Sonoma County Design Review Committee STAFF REPORT

FILE: PLP19-0045
DATE: April 7, 2021
TIME: At or after 1:30 pm
STAFF: Katrina Braehmer, Project Planner

Property Owner: Alisha and Natasha Properties, LLC
Applicant: Ken Di Lillo
Address: 685 Aviation Boulevard, Santa Rosa
Supervisorial District(s): Fourth
APN: 059-340-056
Description: Request for Design Review and a Use Permit for a new 59,066 square foot, 50-foot tall, two-story warehouse, with 500+/- square feet to be used as office space, on a 1.53-acre parcel located in the Airport Business Center. The warehouse is a permitted use, and a Use Permit is required for additional building height above the 28-foot maximum within the building setback line.
CEQA Review: Mitigated Negative Declaration
General Plan Land Use: Limited Industrial
Specific/Area Plan Land Use: Industrial Park
Ordinance Reference: Article 44 – Industrial Park District
Article 82 – Design Review
Article 86 – Parking Regulations
Zoning: MP (Industrial Park) 1 AC AVG (One-acre average), VOH (Valley Oak Habitat)

SITE PLAN

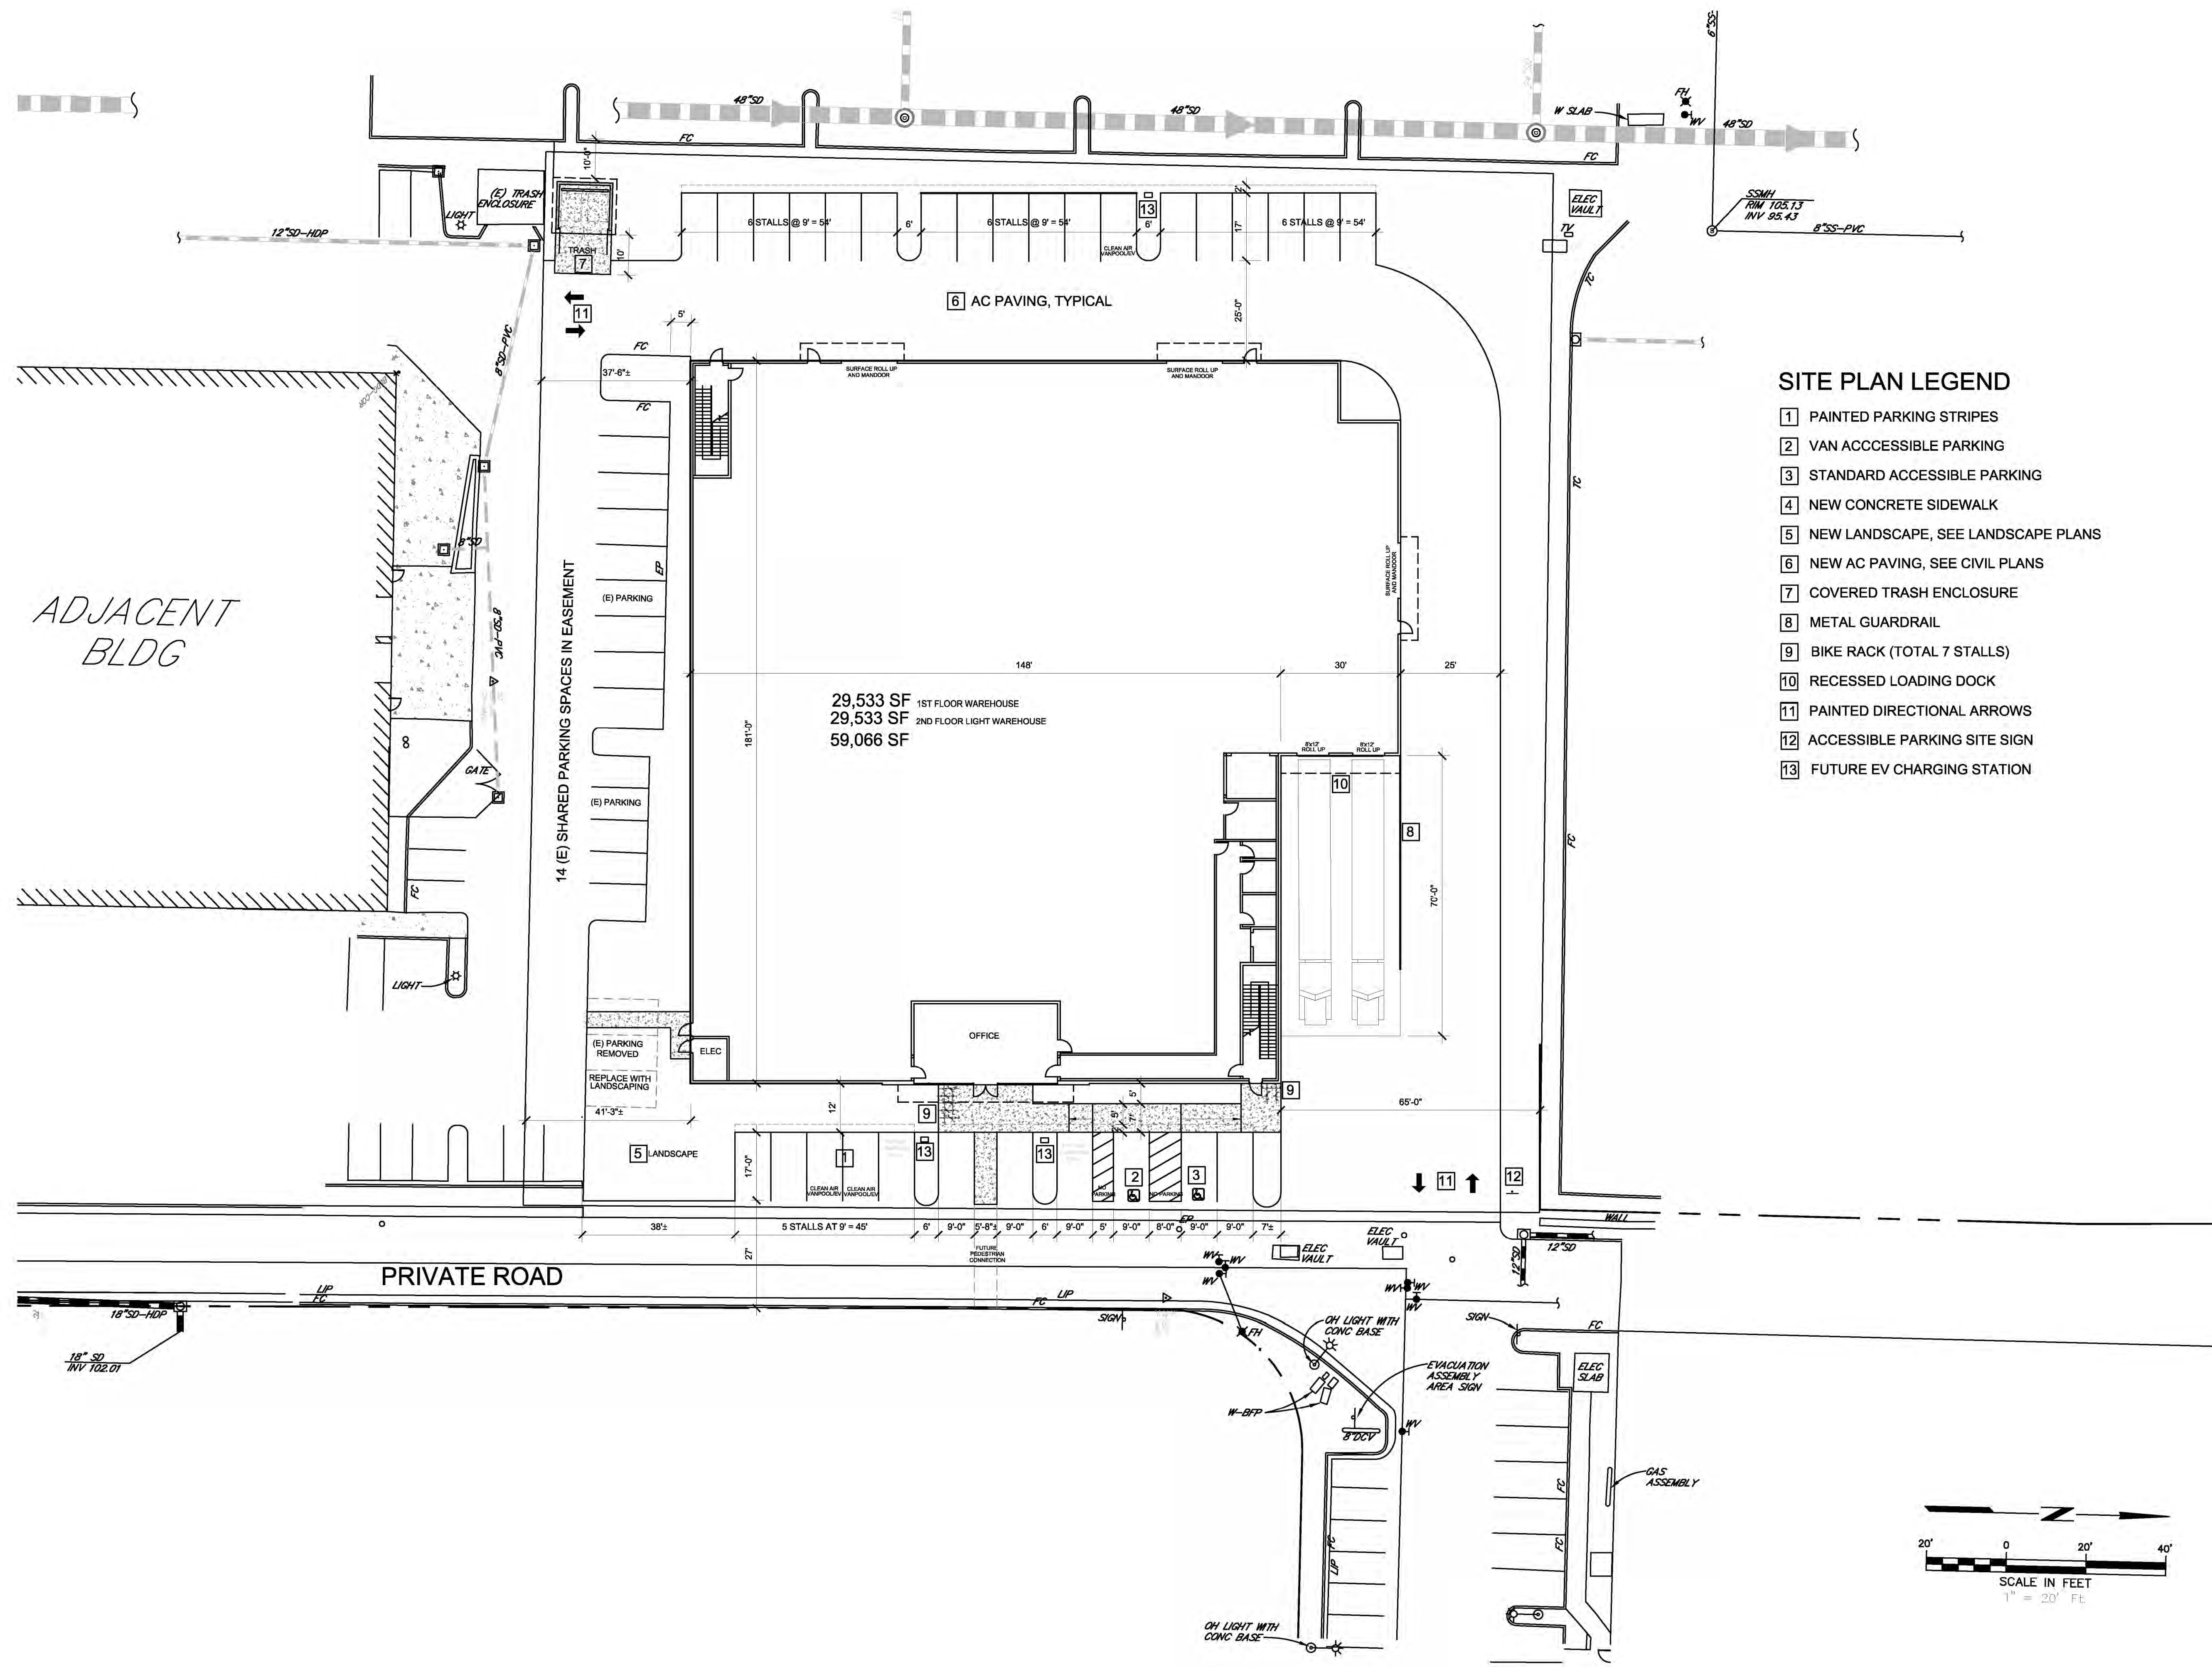
2. Rework overall site plan, parking design, and building footprint to accommodate, required parking space/curb depth dimensions, ADA path of travel width, Specific Plan landscaping requirements at 20% of lot, and unavailability of existing reserved spaces within neighboring parking easement
3. Provide conceptual development plan showing general layout, scale and massing for development of adjacent vacant parcel and last remaining lot under Parcel Map PLP98-0016.

2. Rework overall site plan, parking design, and building footprint to accommodate, required parking space/curb depth dimensions, ADA path of travel width, Specific Plan landscaping requirements at 20% of lot, and unavailability of existing reserved spaces within neighboring parking easement.

We have revised the site plan to achieve the minimum required parking of 30 cars. The parking easement of the south site is a shared parking easement. It covers 14 spaces. We assume that our site could share up to 7 of these spaces. We would only need to share one to have the 30 parking spaces required on site.

The parking space depth dimensions and curb overhang into landscape dimension are shown on the site plan. The ADA path of travel widths are indicated. Landscaping is at 20% of the lot.

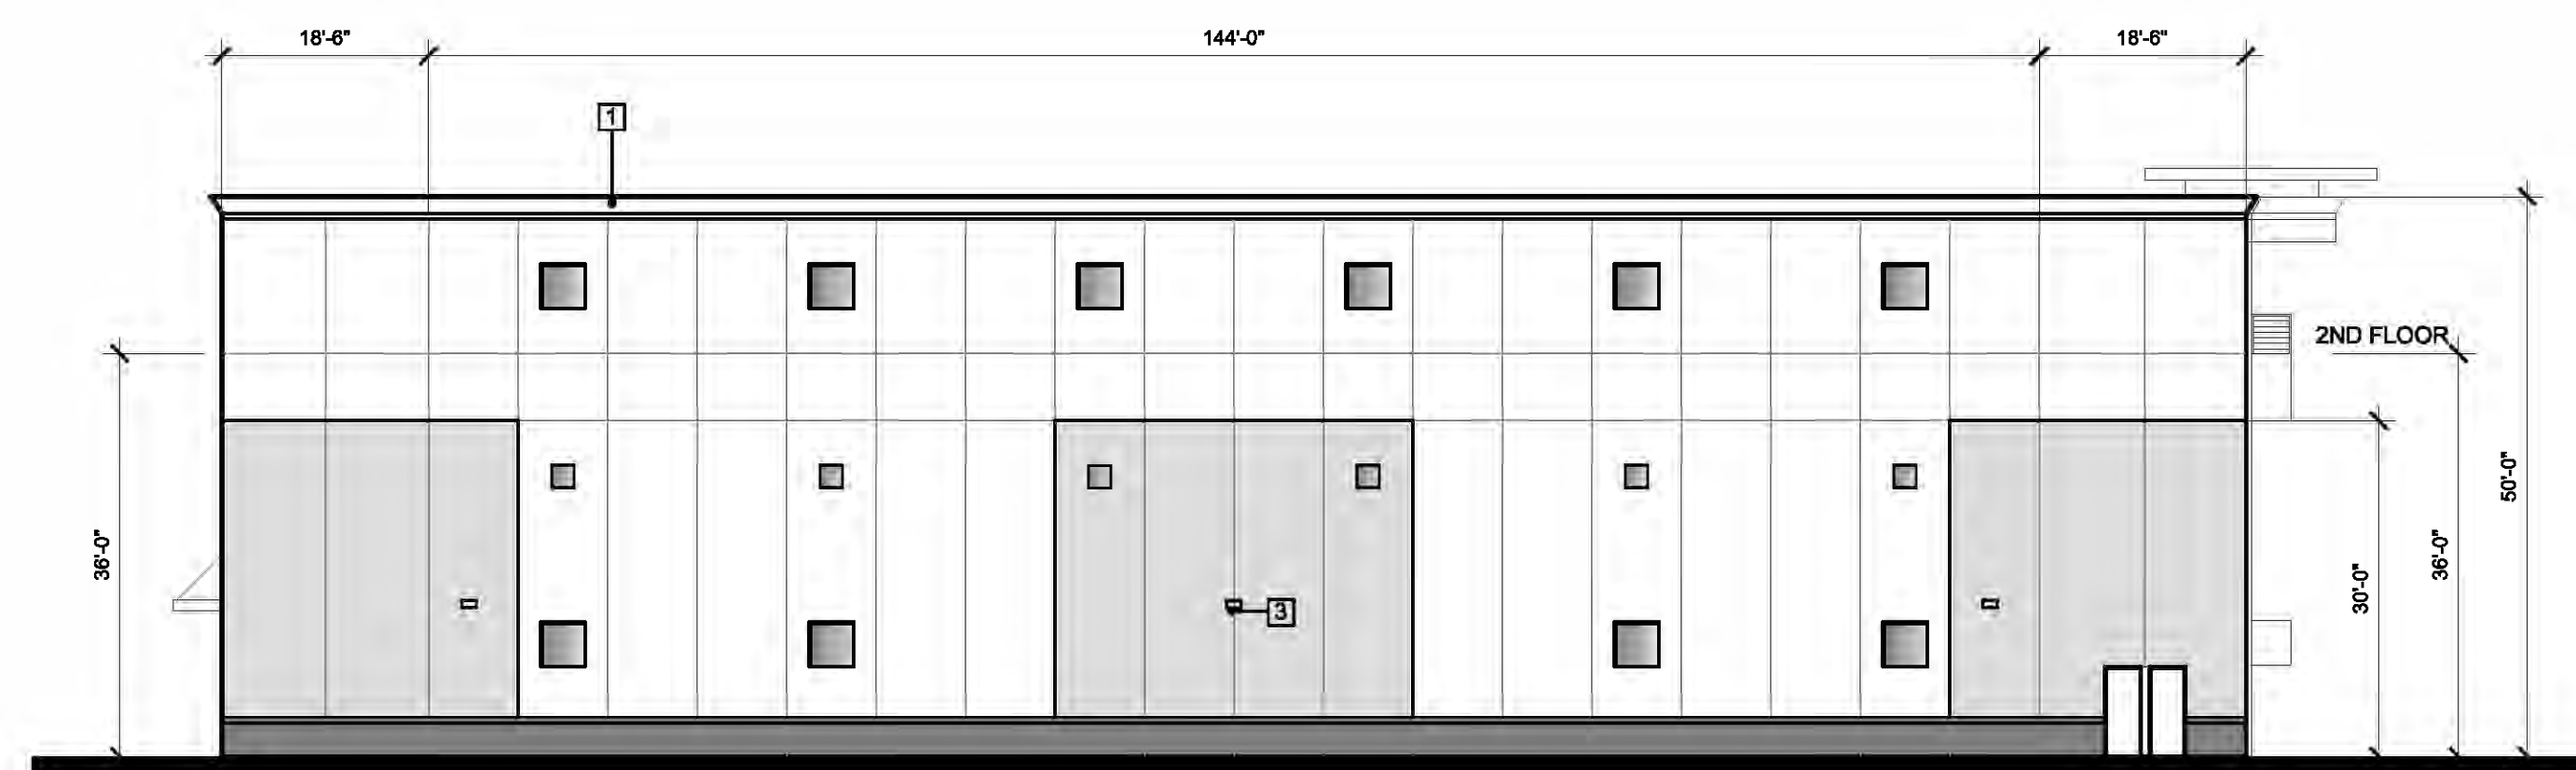
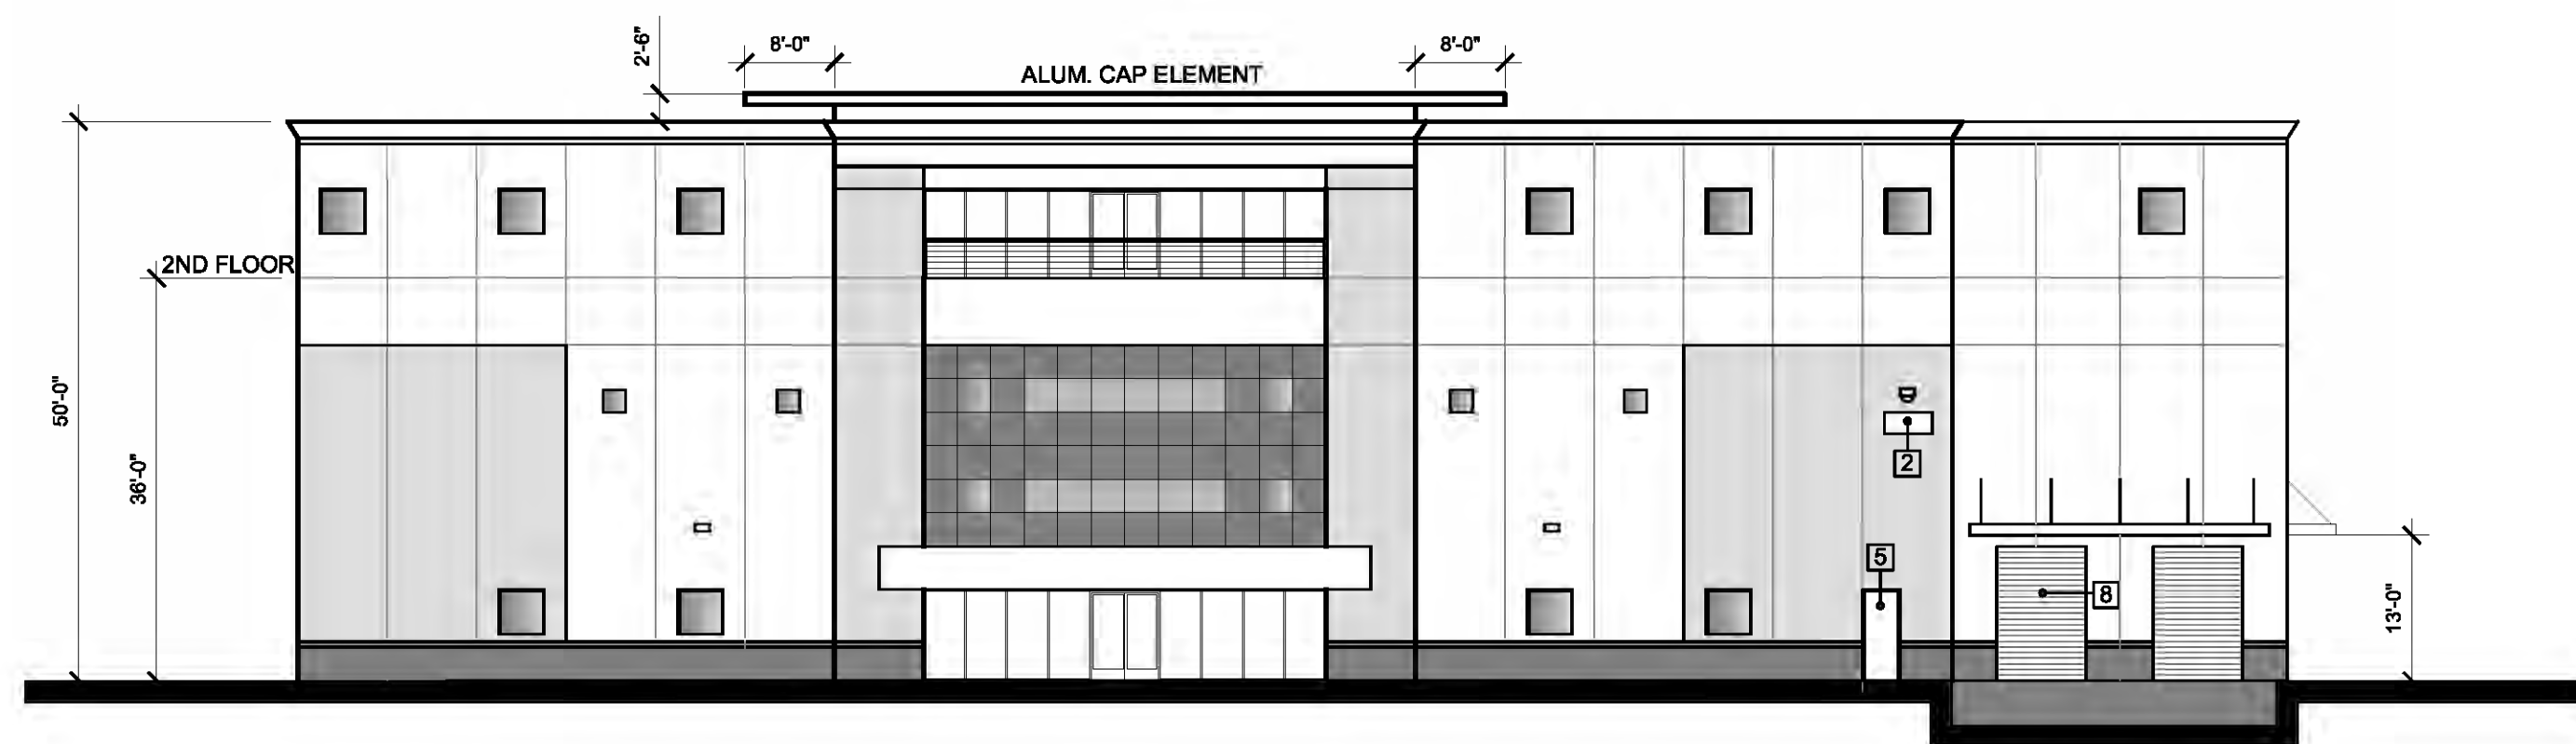
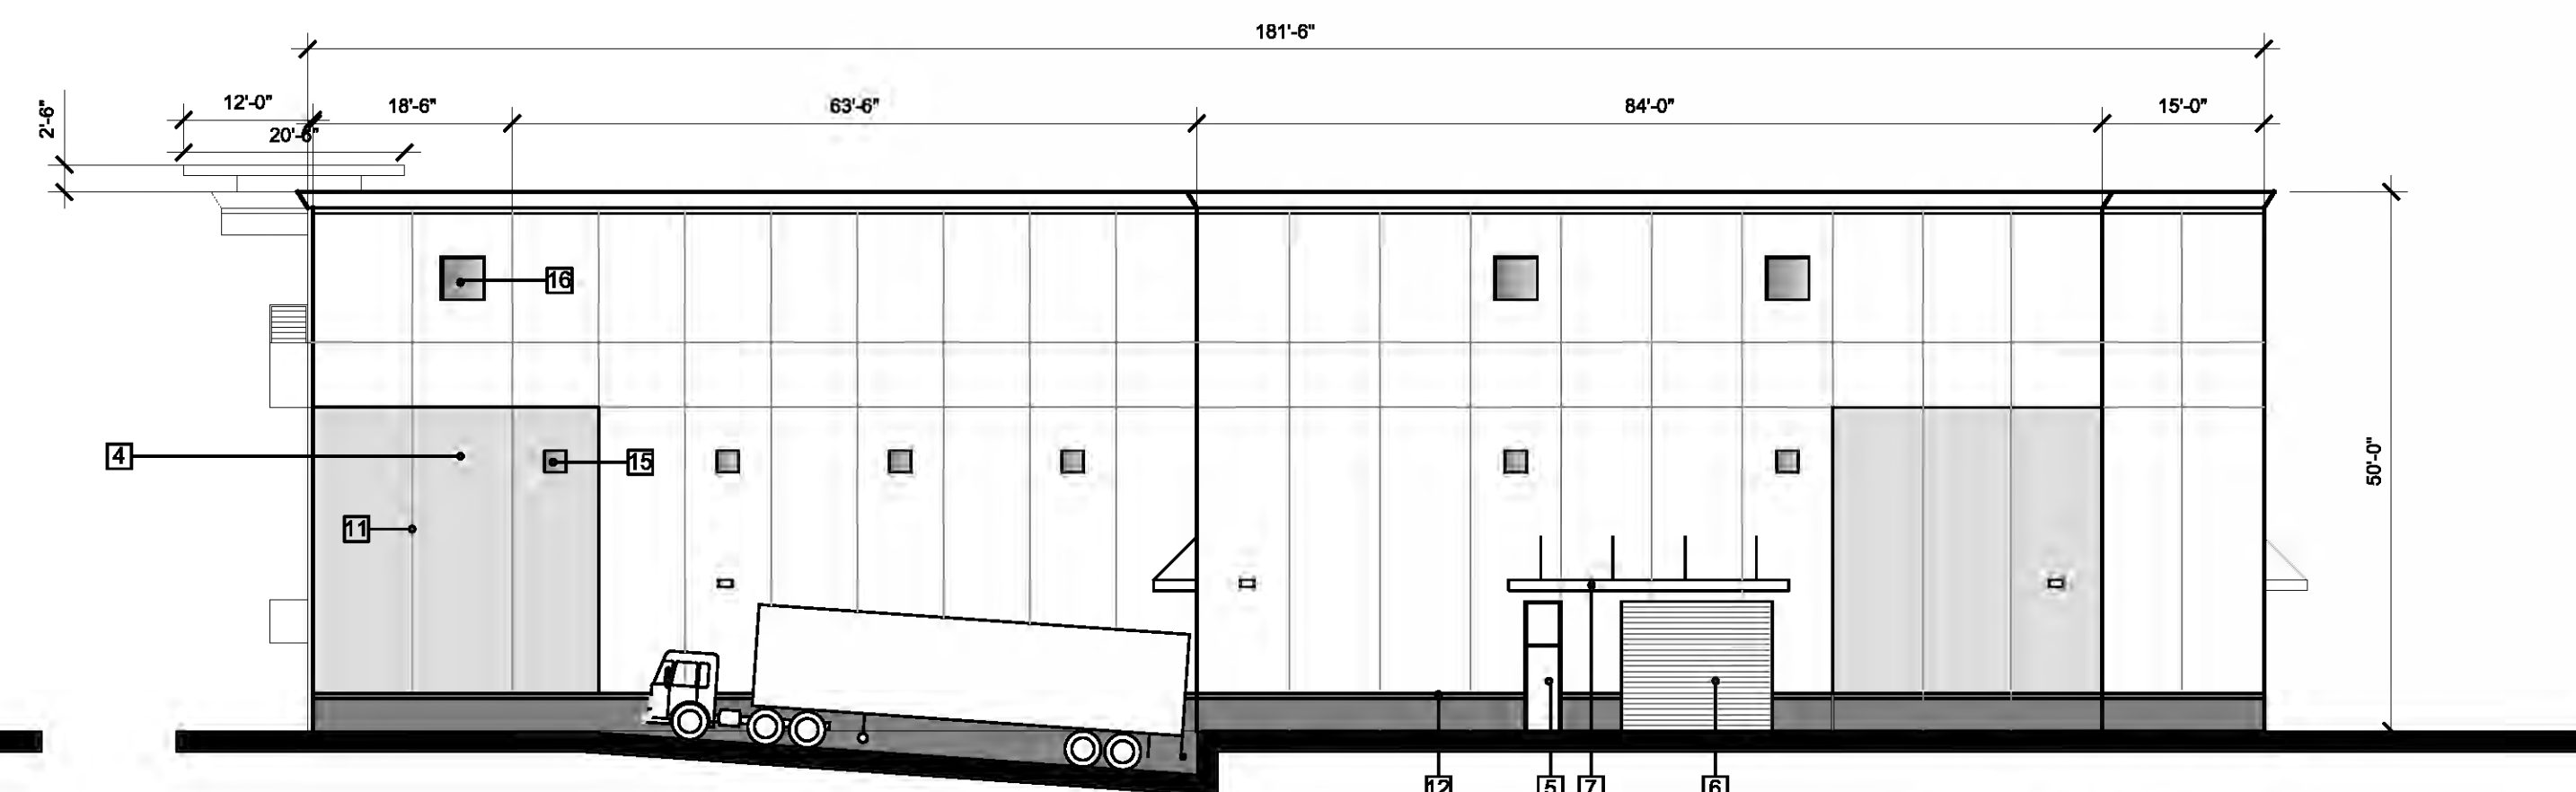
5. Consider revising main façade elevation to enhance articulation of building entry. [The East elevation with the main building entry has been revised.](#)
[We redesigned the projected roof element over the upper balcony to better define the central entry elevation. We made it thinner and less bulky. We added a projected horizontal roof plane element above the soffited area. This is set at 2.5 feet above the main parapet height that is 50 Ft., to create some variation in height and make the central elevation stand out.](#)
[Per Design review comments we added more windows at the ground floor on the east and south elevations.](#)
